RE: Windfall Oil & Gas, Inc.  
Permit # PAS2D020BCLE  
PERMITTED FACILITY: Class II-D injection well, Zelman #1

I am submitting this MOTION FOR RECONSIDERATION OF EAB ORDER DENYING PETITIONS FOR REVIEW of UIC Permit # PAS2D020BCLE for Windfall Oil & Gas to construct and operate the Zelman #1 Class II Disposal Injection well.

## **RICHARD L. ATKINSON'S MOTION FOR RECONSIDERATION OF EAB ORDER DENYING PETITIONS FOR REVIEW**

EXHIBIT C

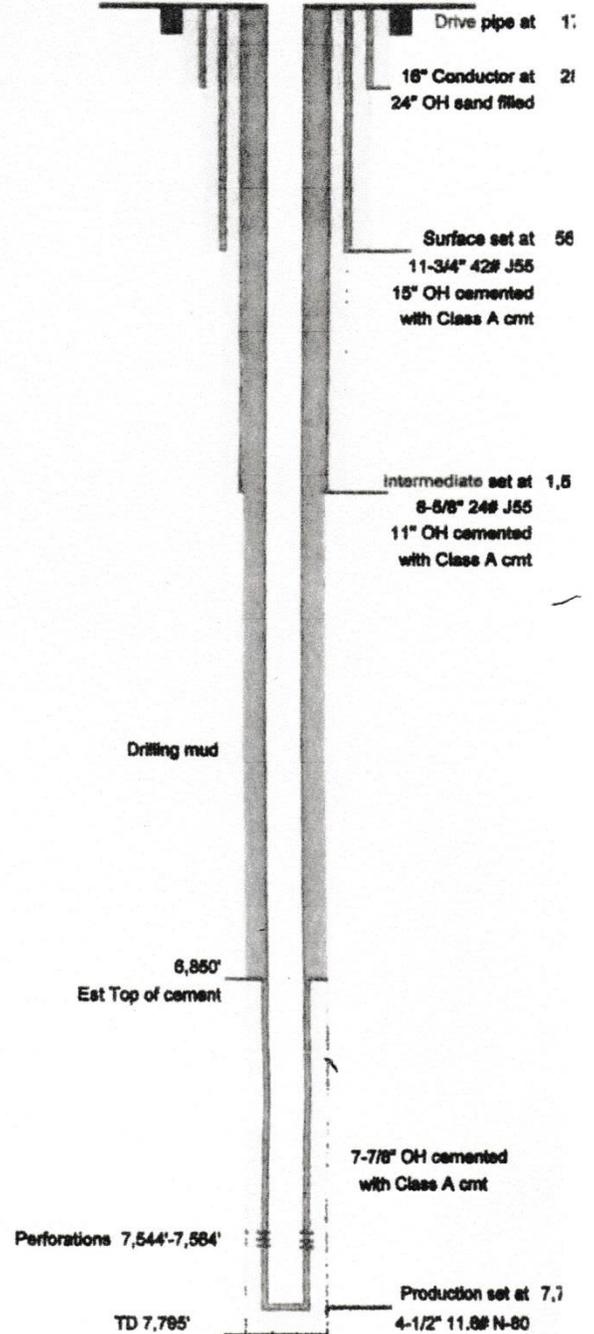
1. There may not be enough bentonite in the drilling mud, since it does not circulate as it does during the drilling process, to adequately seal the pores in the formation at the seat of the 1539 foot casing. The drilling record shows sand and shale at that depth.
2. Assume that .1% of the waste fluid leaks into the wellbore at a disposal rate of 30,000 barrels/month. In that case, potentially 30 barrels/month of drilling fluid will have to be removed from the annulus.

The opinion of this commenter is that PGE should be required to drill a monitoring water well. This well should be 562 feet deep into the lowermost USDW. It should be less than 100 feet away from the disposal injection well. The monitoring well water should be tested 4 times a year to detect any contamination.

The best way to operate a disposal injection well with a section of open wellbore would be to have provisions to measure the pressure at the seat of the surface casing and to pump out and reinject any leakage.

WINDFALL DIW # PAS2D020BCLE EXHIBIT D

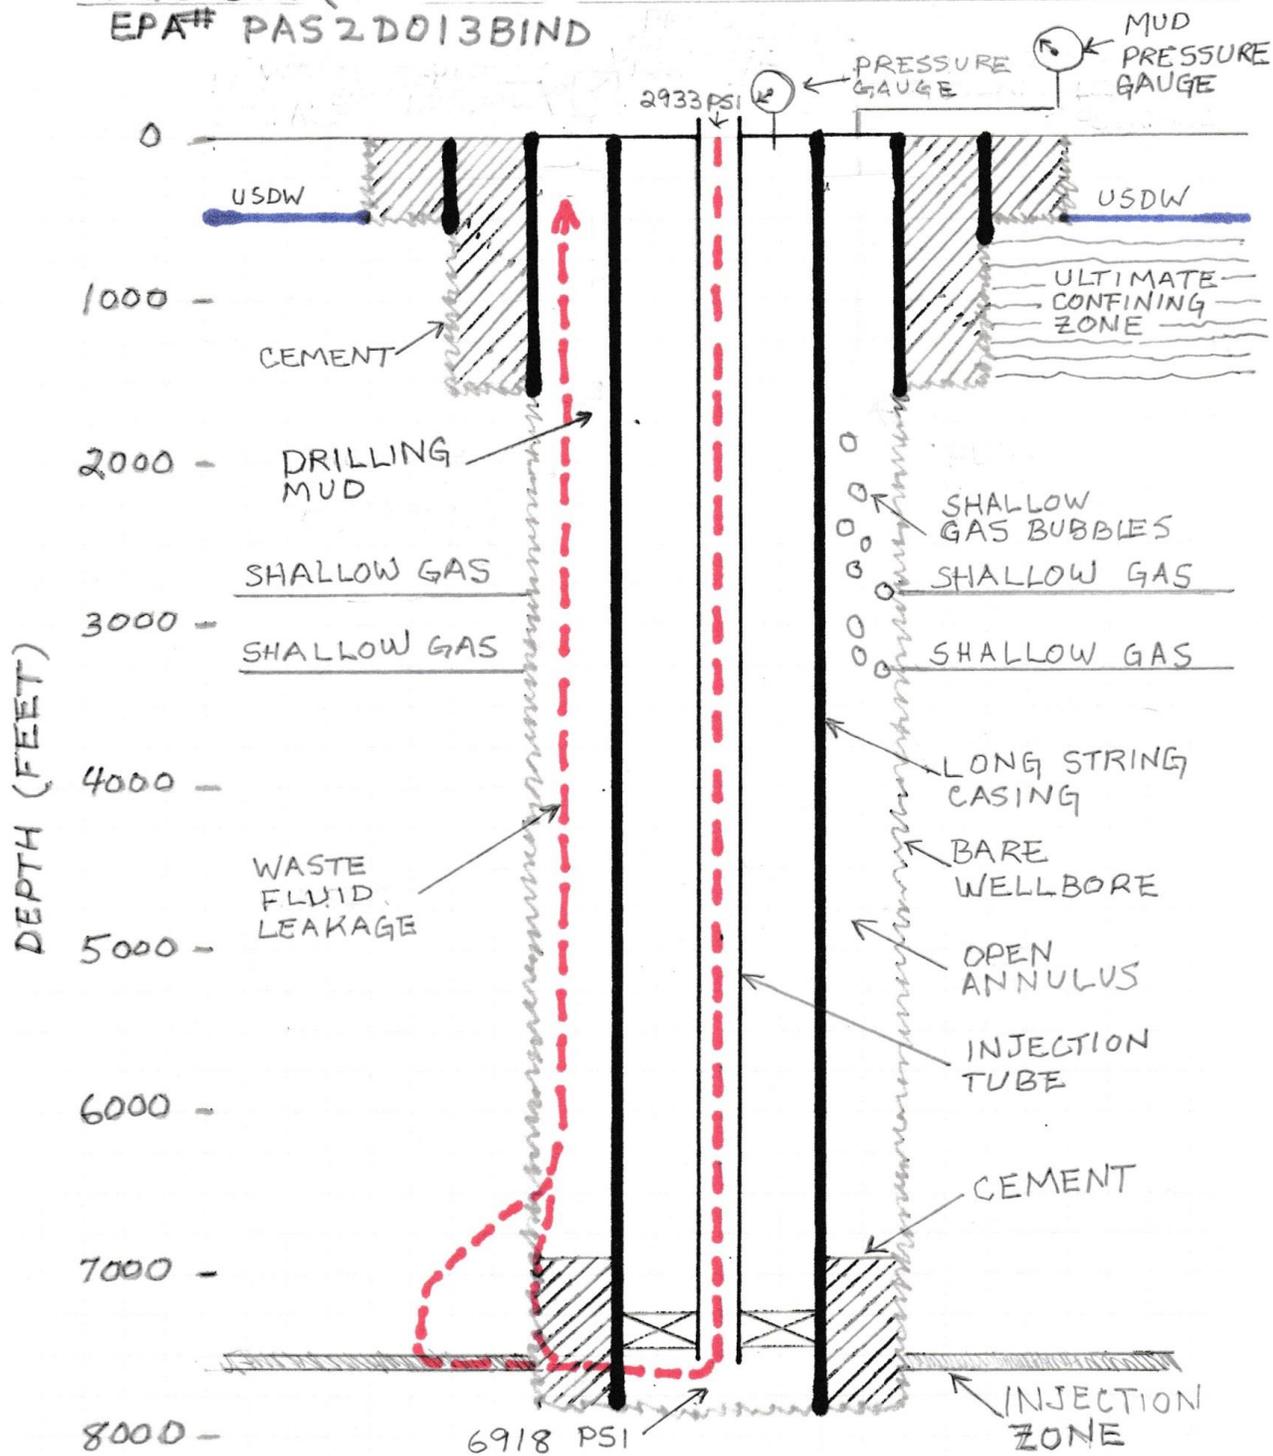
The issue of overpressuring of the open annulus of the long string casing–surface casing by waste fluid leakage around the bottom cement seal was not raised during the public comment period.

If (1) the long string casing-surface casing annulus is shut in, and (2) there is a slow leak bypassing the cement seal at the bottom of the long string casing, then there could be enough pressure transmitted through the virtually incompressible drilling mud to fracture the confining layer at the seat of the surface casing.

Therefore, if the cement seal at the bottom of the long string casing is going to leak, the waste fluid pressure will be 6918-367 = 6551 psi, which is too high for the drilling mud to stop the leak.

There is one advantage of having the annulus filled with drilling mud; the liquid mud is virtually incompressible. The pressure produced by the leak minus the pressure due to the weight of the drilling mud will be transmitted immediately to the surface gauge.

If the drilling mud is pressurized, then the possibility of fracturing the confining layer adjacent to the lowermost USDW comes into play. (EPA UIC Permit Part III B.4.)

It turns out that the fracturing will occur when the mud surface pressure (SP) is equal to the difference of the fracture pressure gradient (FPG) and the mud pressure gradient (MPG) times the depth (D) at the seat of the 1540 foot surface casing:  $SP = (FPG - MPG) D$

For example, if the fracture pressure gradient is .7 psi/foot and the mud pressure gradient is .5 psi/foot, then fracturing at 1539 feet would occur when the mud gauge reads 308 psi.

The EPA UIC permit should specify that the long string casing-surface casing annulus be filled to the surface with freshwater-bentonite drilling mud.

The weight of the drilling mud should also be specified.

A drilling mud pressure gauge should be required on the long string casing-surface casing annulus with an automatic injection pump shut down feature, similar to the system required on the injection tube-long string casing annulus.
